Subject: FCC Class II Permission change for FCC ID: 2AIZN-YY-S-X6855  
Original Grant Date: 12/12/2024

This is to request a Class II permission change to our Mobile Phone; Model: X6855, FCC ID: 2AIZN-YY-S-X6855, the device is identical to the previously certified except for the changes as below for details:

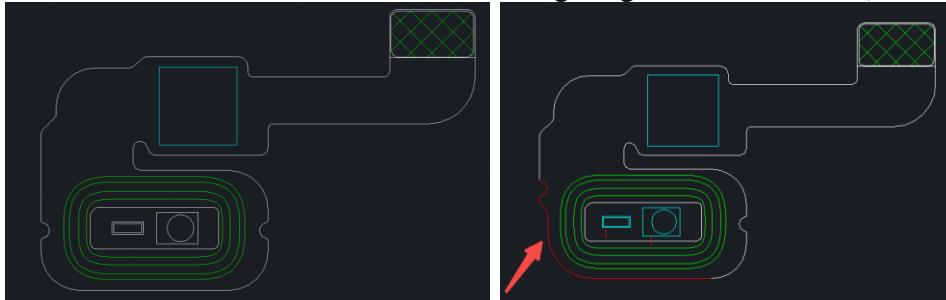
1. WPT Antenna: Enlarged appearance (The total length of the FPC dimensions is increased by 7.55mm, the width is increased by 10mm, and the charging power remains unchanged);
2. MINI LED FPC, Reduced appearance (Cut the red line pointed by the arrow 0.6mm inwards, which will not affect the lighting function or color.)
